AGENDA FOR THE INDEPENDENT HEARING AND ASSESSMENT PANEL MEETING

4 September 2017

ITEM 1	Application to amend Bankstown Local Environmental Plan 2015: 913 to 925 Punchbowl Road and 21 Canterbury Road, Punchbowl
DATE OF LODGEMENT	11 July 2017
APPLICANT	CMT Architects Pty Limited
AUTHOR	Planning

ITEM 2	680 New Canterbury Road, Hurlstone Park
	Demolition of existing structures and construction of shop top housing development consisting of 14 apartments over five storeys with two levels of basement car parking and one ground floor retail premise
FILE	DA-645/2015 - Canterbury Ward
ZONING	B2 Local Centre
DATE OF LODGEMENT	23 December 2015, further information received up until 1 May 2017
APPLICANT	Environa Studio
OWNERS	Eastside Projects Pty Ltd
ESTIMATED VALUE	\$5,535,220
SITE AREA	613.3m² (by title)
AUTHOR	Planning

Figure 5: Western Elevation

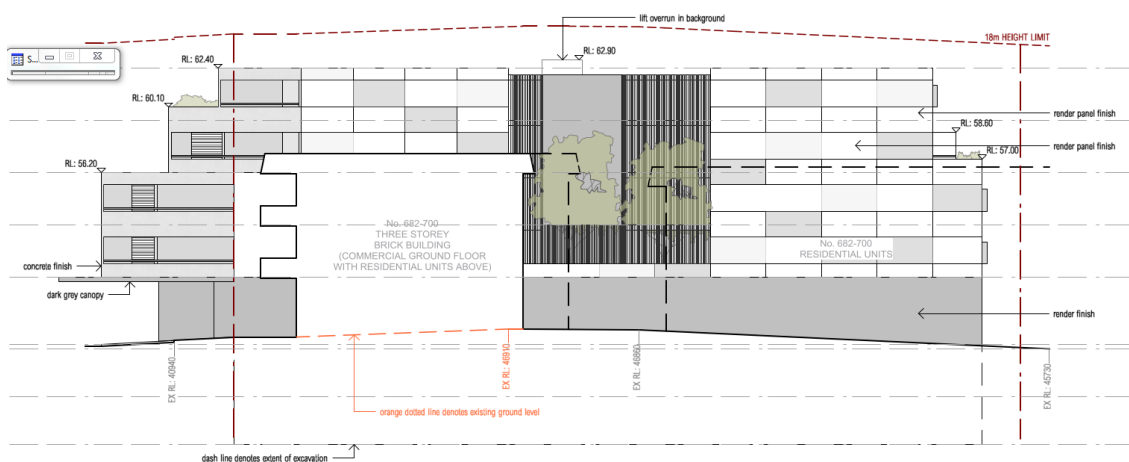
The building has been designed to present as two separated structures to improve solar access to the principle living areas and associated private open space area of each apartment (refer to **Figure 5** below).

Figure 6: Side Setback (red line indicates building envelope requirement)

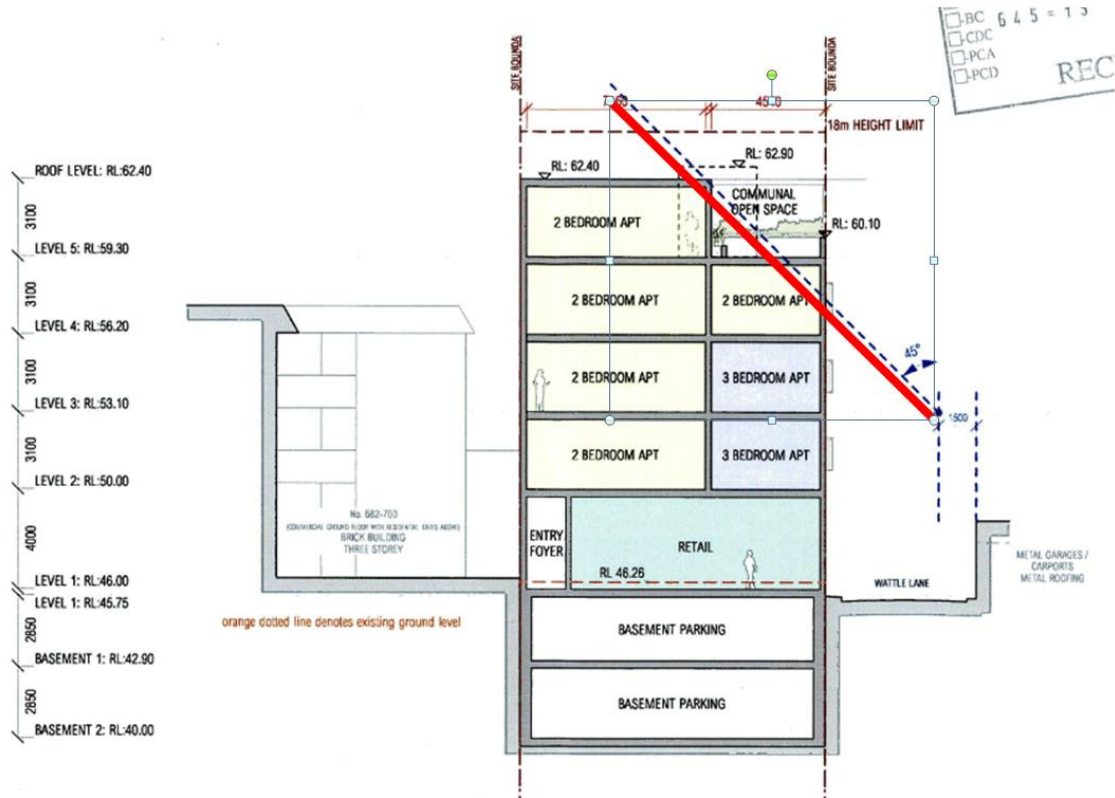
As outlined within the figures below, the proposed design marginally encroaches the 45 degree building height plane along the side elevation (eastern elevation) as well as along the rear elevation (southern elevation), particularly on the upper levels (Levels 4 and/or 5). Furthermore the design does not comply with the two storey height limit on either elevation as a four storey design is proposed along the eastern elevation and a three storey design is proposed along the southern elevation.
